DEPARTMENT OF PARKS AND COMMUNITY SERVICES

March 27, 2024

Subject: Bull Hill and Rolling Meadows Sketch Plan (SKP-23-003)

Bull Hill and Rolling Meadows Sketch Plan Review

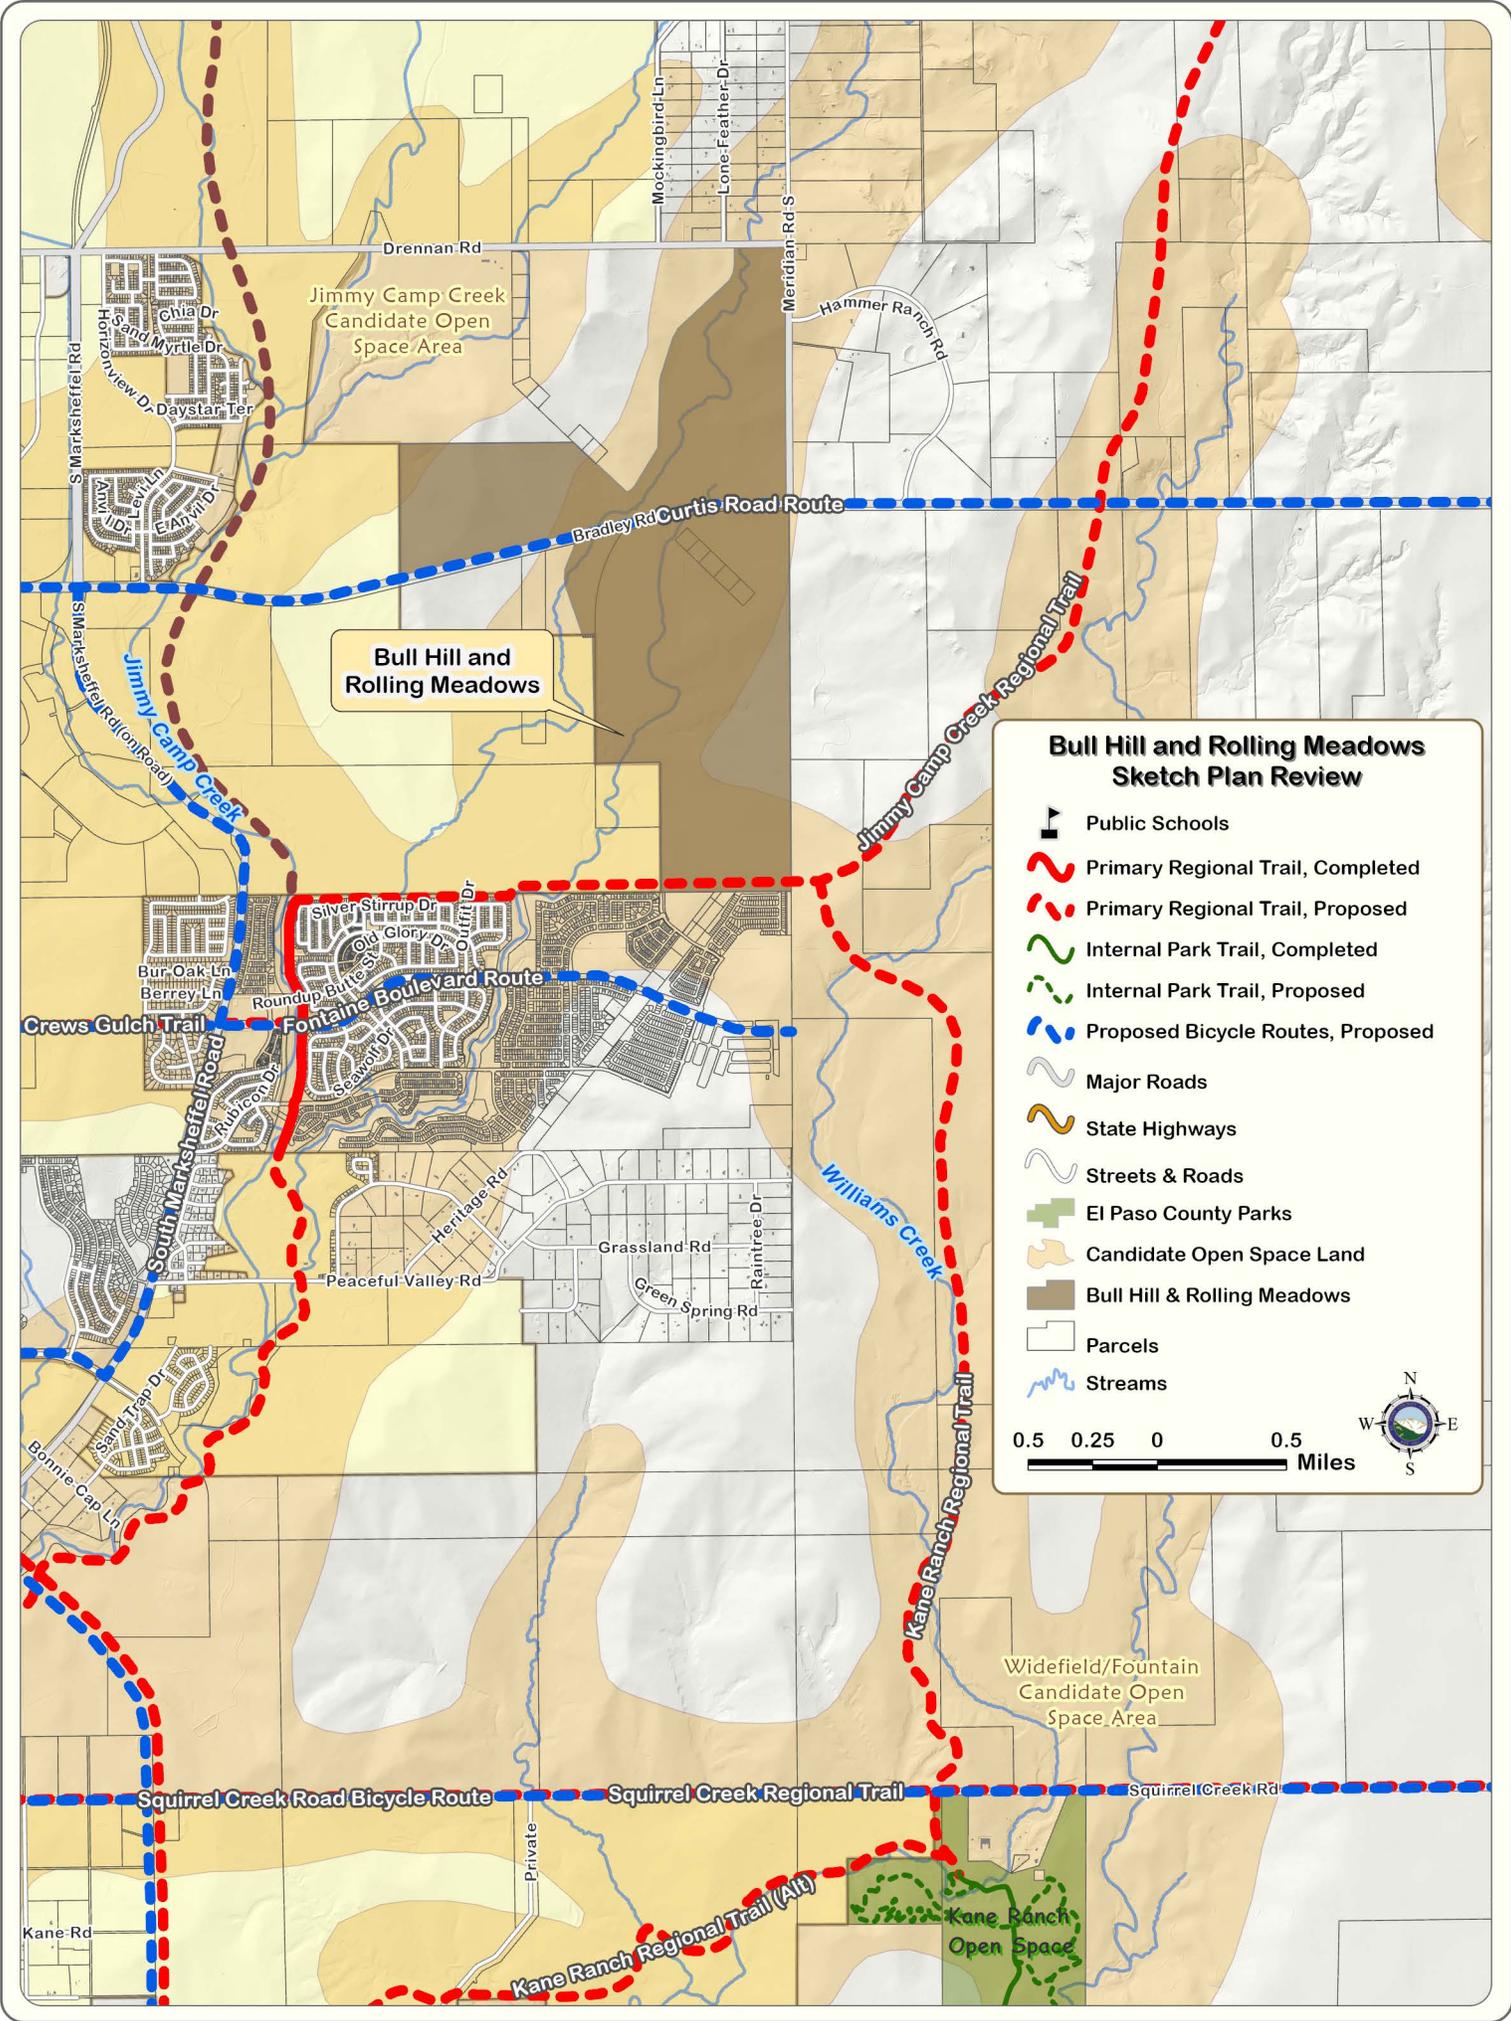
The 2022 El Paso County Parks Master Plan shows one proposed primary regional trail and one proposed bicycle route impacted by the project. The proposed Jimmy Camp Creek Primary Regional Trail is located along the southernmost property boundary, running east-west immediately adjacent to the northern boundary of the existing Lorson Ranch development. When completed, the Jimmy Camp Creek Regional Trail will connect the Town of Fountain to the City of Colorado Springs' Corral Bluffs Open Space. The northern terminus of the proposed Kane Ranch Primary Regional Trail is located immediately southeast of the project site, intersecting with the Jimmy Camp Creek Regional Trail near the project's southeasternmost corner and providing future connectivity to Kane Ranch Open Space and Clear Spring Ranch Open Space to the south.

The proposed Curtis Road Bicycle Route bisects the Sketch Plan east-west along Bradley Road. A dedicated public right-of-way already exists along Bradley Road, so no additional easement requests are necessary at that location; however, the applicant is advised that multi-modal transportation options may be developed within the right-of-way in the future.

The Candidate Open Space Area Master Plan of the Parks Master Plan shows the Jimmy Camp Creek Candidate Open Space Area encompassing a large portion of the project site, although the site is located on a minor tributary and not on the main creek channel. Natural resource values here include critical wildlife habitat, wetlands, and riparian vegetation. Water quality protection is a concern in this area that drains to Fountain Creek and where the Widefield aquifer is close to the surface. The project would not be in conflict with the plan, as long as its development does not adversely affect the surrounding existing environment. The applicant has included approximately 123.1 acres of open space areas that encompass drainage channels, floodplains, and non-jurisdictional wetland areas.

EPC staff is encouraged by the applicant's willingness to provide a variety of recreational amenities for its residents and citizens of El Paso County through the development of an expansive and connected park, trail, and open space system. Staff recommends that the developers, through forthcoming Preliminary Plans and Final Plats, designate and provide to El Paso County

a 25-foot public trail easement along the southern boundary of Bull Hill and Rolling Meadows for the purpose of construction and maintenance of the Jimmy Camp Creek Primary Regional Trail. Lastly, staff recommends regional and urban park fees in lieu of land dedication on all forthcoming Final Plats.

“The Park Advisory Board recommends that the Planning Commission and the Board of County Commissioners include the following conditions when considering and/or approving the Bull Hill and Rolling Meadows Sketch Plan: (1) designate and provide to El Paso County a 25-foot public trail easement along the southern boundary of Bull Hill and Rolling Meadows, that allows for public access, as well as construction and maintenance by El Paso County of the Jimmy Camp Creek Primary Regional Trail; (3) the trail easement shall be shown on all forthcoming Preliminary Plans and Final Plat(s), and the aforementioned easement shall be dedicated to El Paso County on the forthcoming Final Plat(s); (4) fees in lieu of land dedication for regional and urban park purposes will be calculated upon review of forthcoming Preliminary Plans and Final Plats, and will be required at time of the recording of the forthcoming Final Plats. Park Lands Agreements may be acceptable alternatives to urban park fees provided the agreements are approved by the County and executed prior to recording the forthcoming Final Plat(s).”
